Memo

Subject: Comments on Functional Life Test

Fig. 1. Test results for the 5 different contact designs

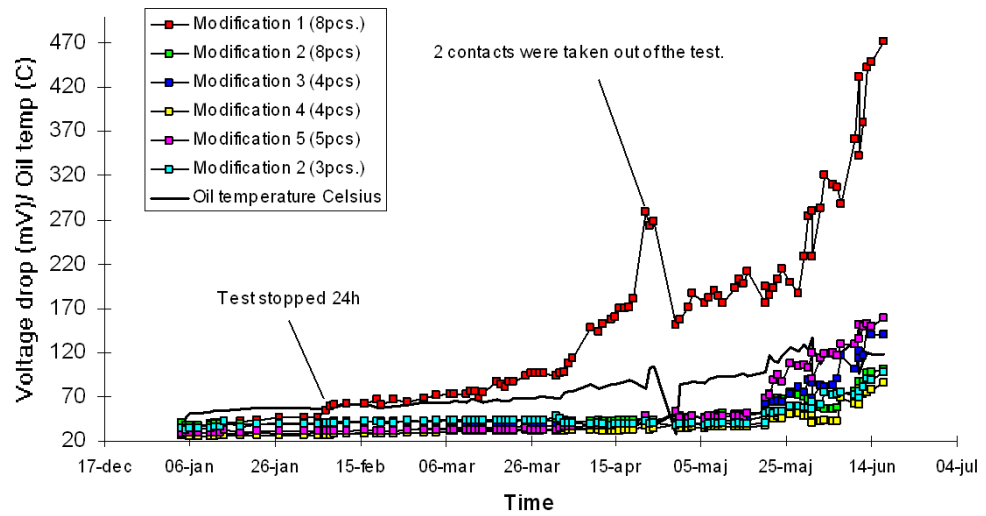
The stability of contacts has statistical variations. In fig. 1 are the results from 5 different contact designs, with several pieces of each design. All the contacts were intended for the same purpose. The load on the contacts varied during the test time. All contacts were placed in the same tank in a similar way. The results of the test will give a very good indicator of the quality of the different designs.

Fig. 2. Test result for the individual contacts of modification 1.

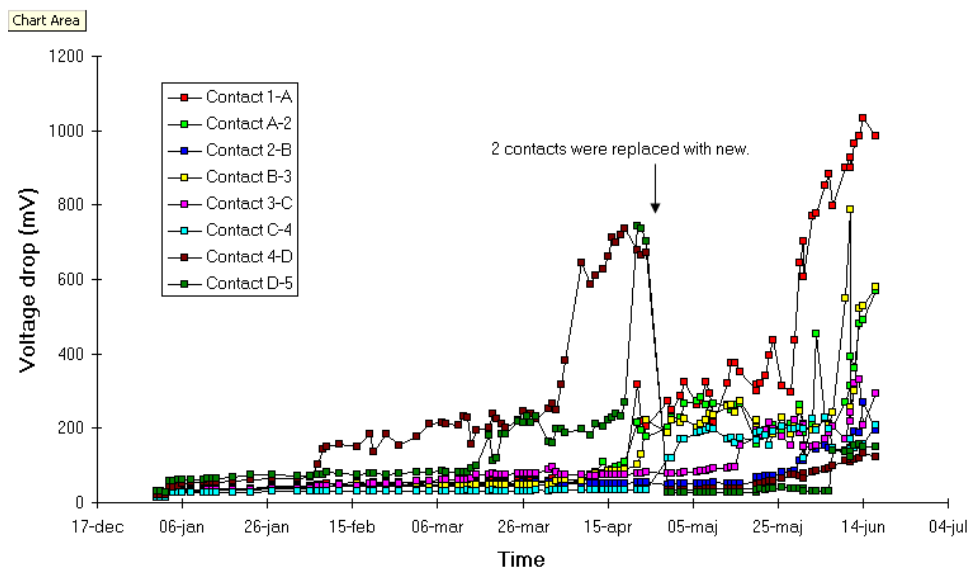
If we look into the individual result of the worst contact modification 1 in fig 2, we can see that there is a large statistical variation. Some of the contacts behaved rather well while other didn't.

It should although be noted that a better contact design gives less variation in result.

Fig. 4. Contacts with different preparation before the test

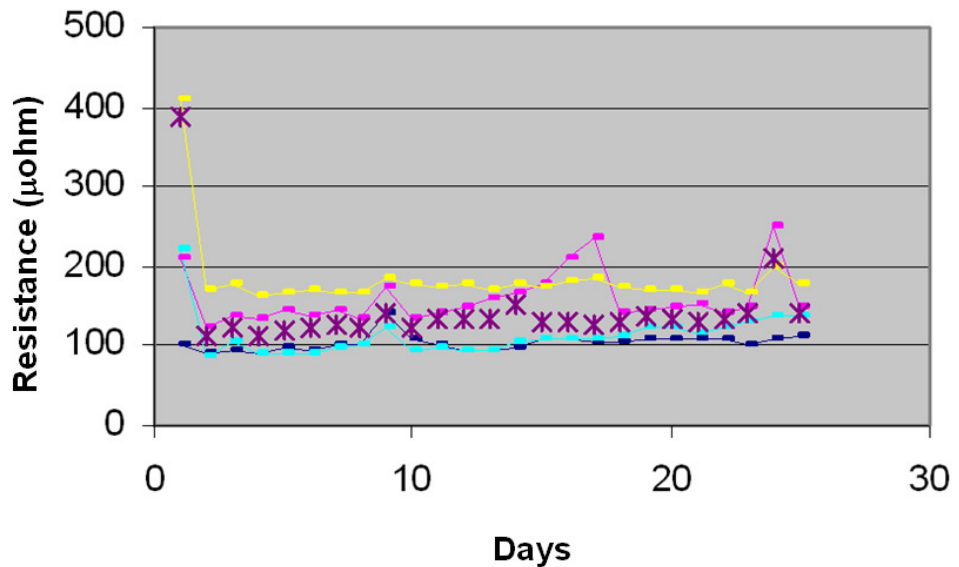
In below fig. 4 the contacts have been prepared before the start of the test. The resistance has decrease for 4 of the contacts during the test. This test shows that that start condition of the contacts is important as also a too high start resistance will not influence so much on the rest of the test.

Fig. 5. Test when the resistance had a steady increase

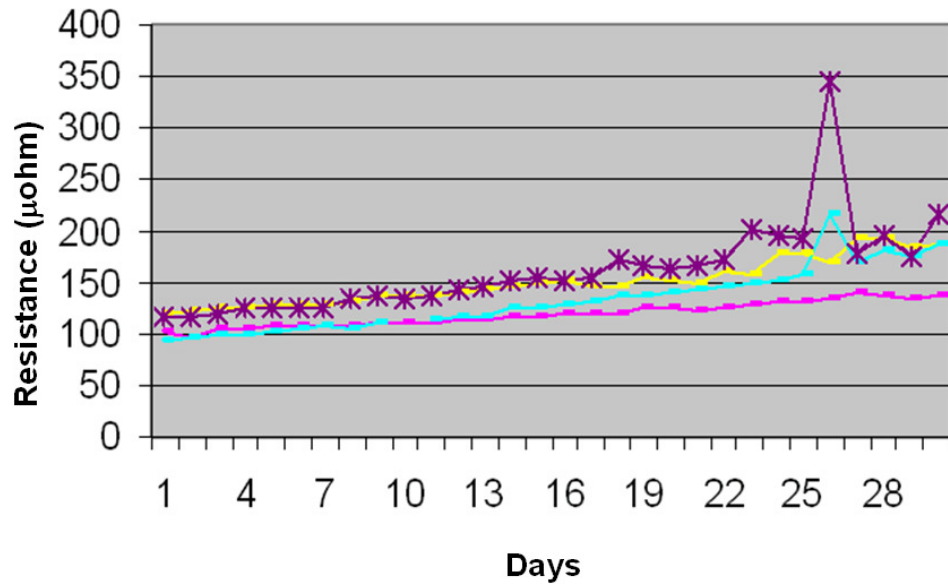
Are these stable increases in fig 5 of concern if the contacts have not moved during the test time that should equal 30 years?

- Should also contacts be rejected that has a low enough value (<25% increase) but are increasing?
- Contacts that include a large portion of bulk resistance will give a better result.
- In case of low resistance and high currents, when measuring voltage drop, the inductance will add to the result and give lower rise values.
